LEGG ARCHITECTURE, LLC

May 03, 2023

Lion & Rose British Tavern and Pub - 23110 W I-10, San Antonio, TX 78257

ADDENDUM 1

SHEET NO.
E2.1

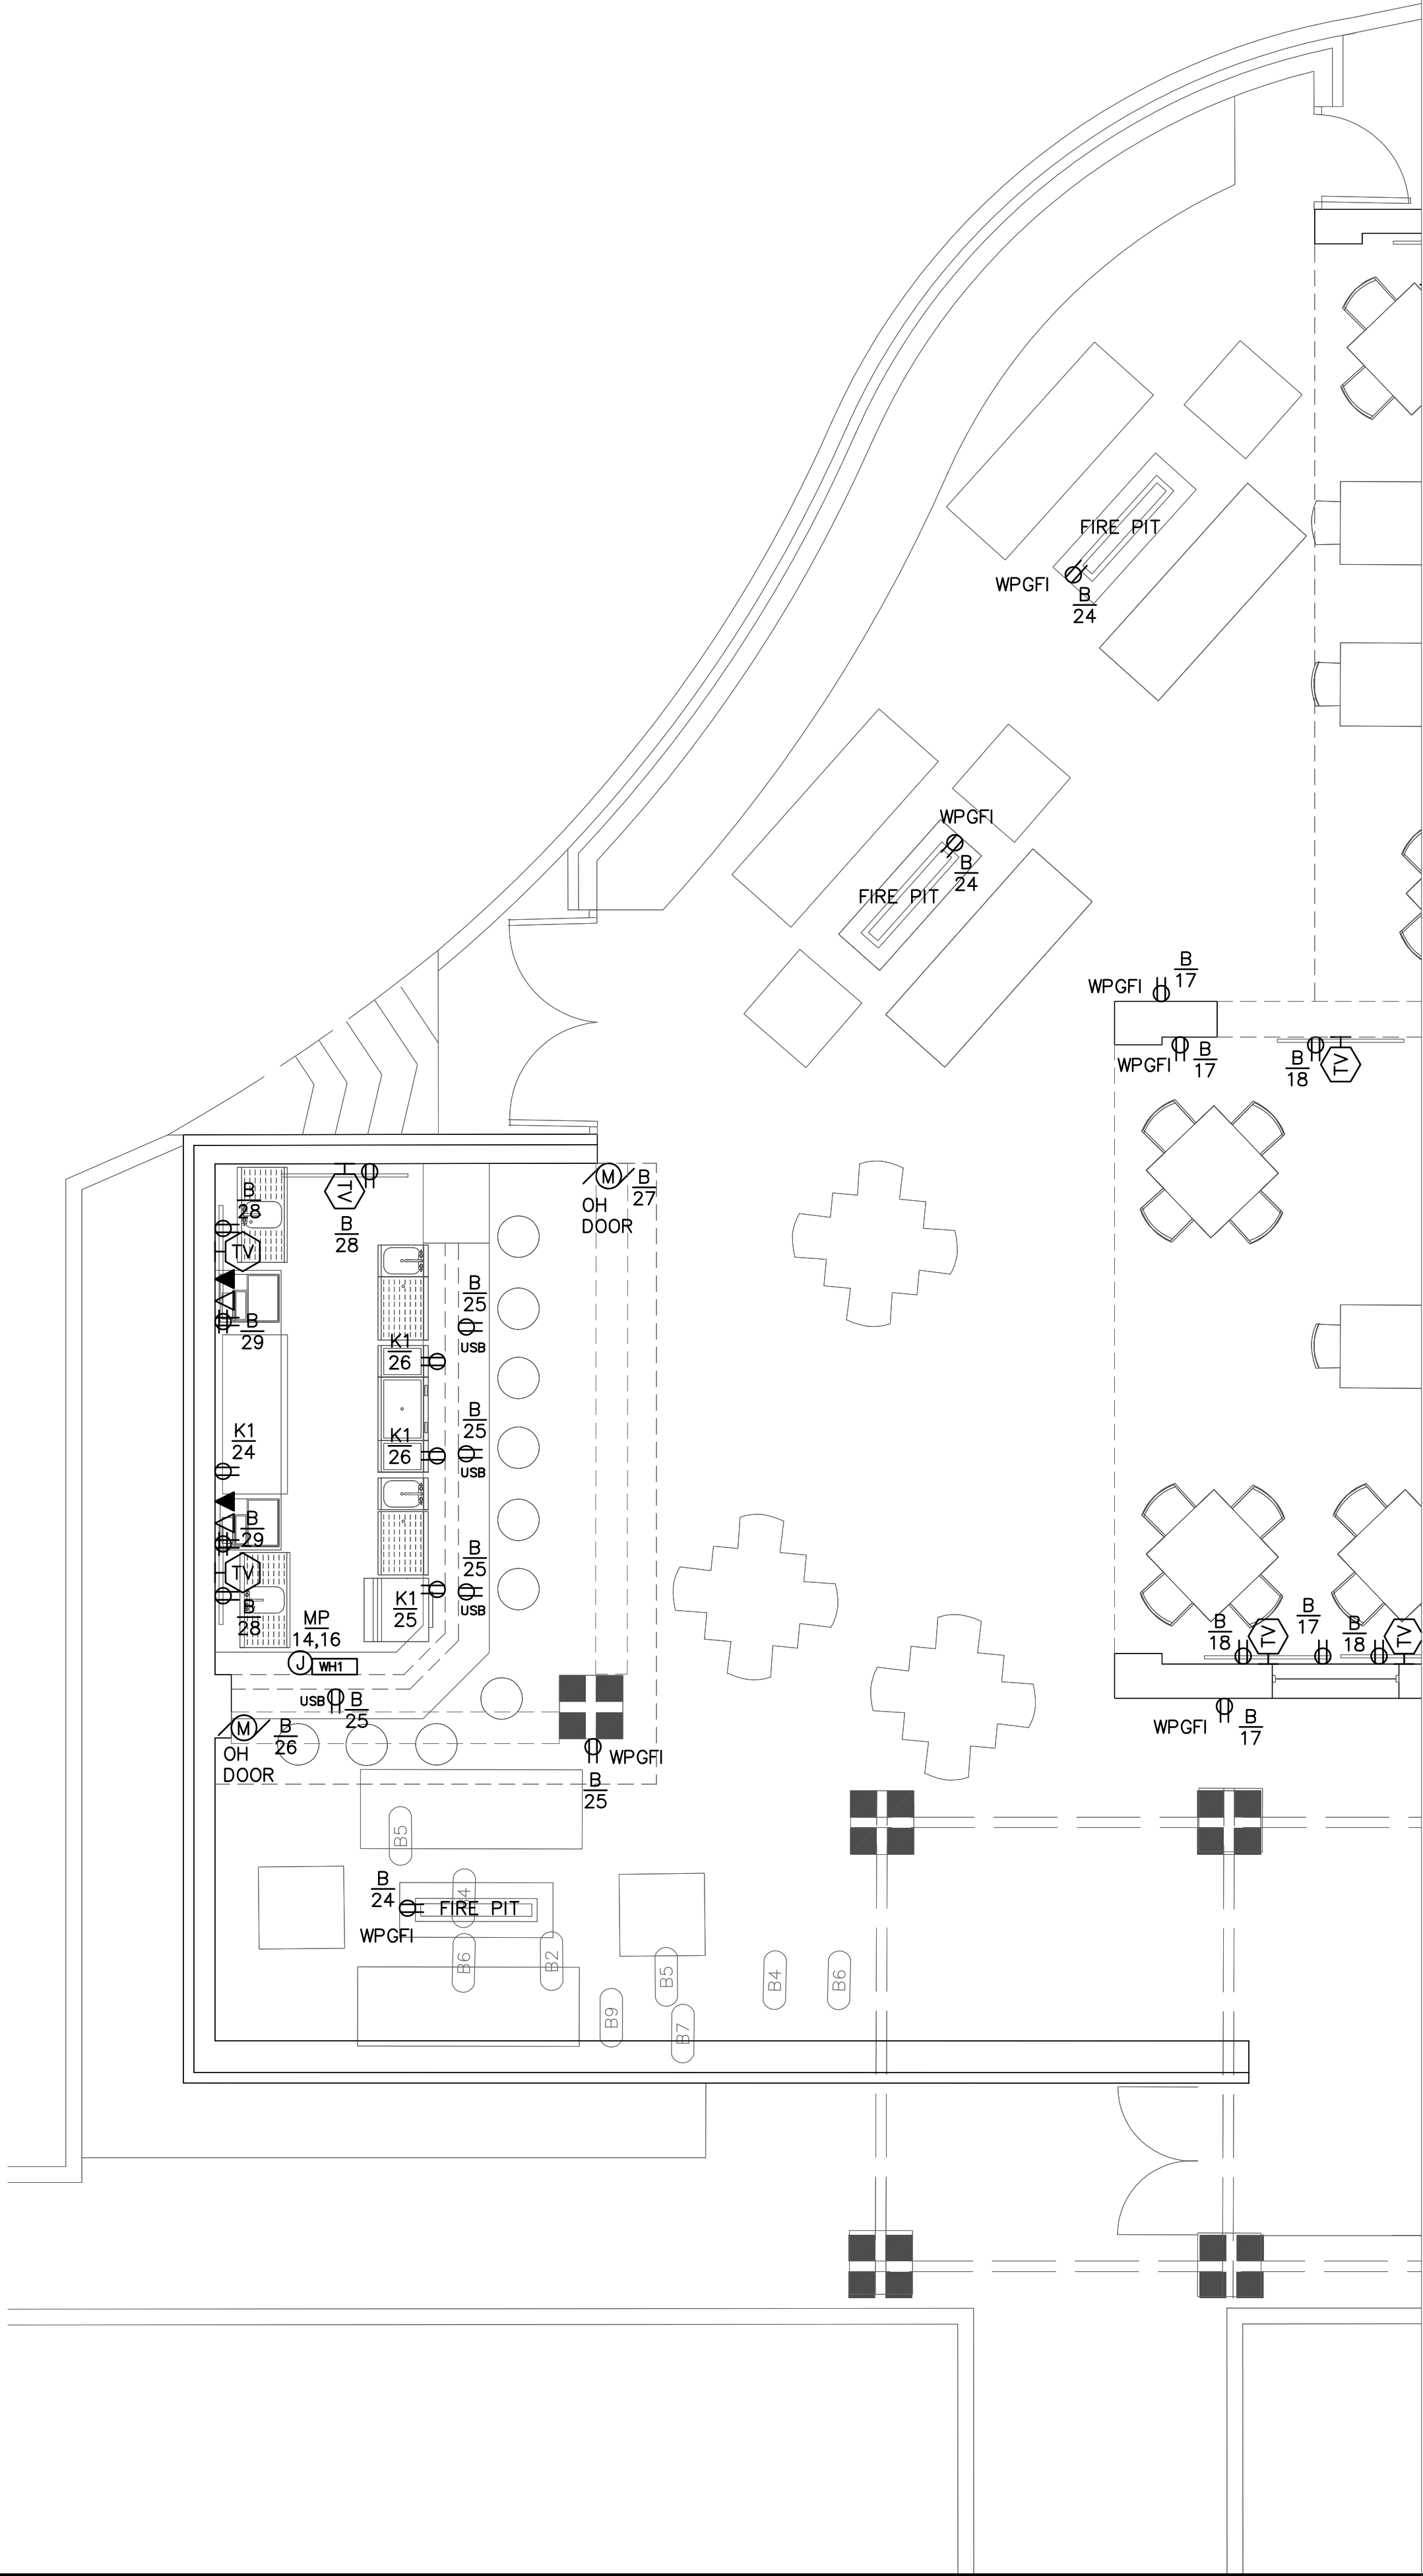
- 2.1 P1.1 Rev 02- Revised plumbing plan – patio pub waste connected to main sewer prior to grease trap
- 2.2 E1.1 rev 02; E2.1 Rev 02; E3.1 Rev 02; E3.2 Rev 02;

- 2.2.1 Media conduits to media closet not office space. (Owner will divert to managers office)
 - 2.2.2 Added outlets - Internal outlets for remote blinds at all **west** facing windows and at front patio pergola **west** columns for exterior patio blinds.

- 2.2.3 Additional outlets for margarita machine; LED bar shelves on bar wall & central main bar island.
 - 2.2.4 Additional outlets for Patio Bar beverage machine & bag in box

- 2.2.5 Add CATV outlet to center of main bar tv wall
 - 2.2.6 Add outlet at NW patio wall corner
 - 2.2.7 Add recessed downlighters to new display cabinet in Patio Bar
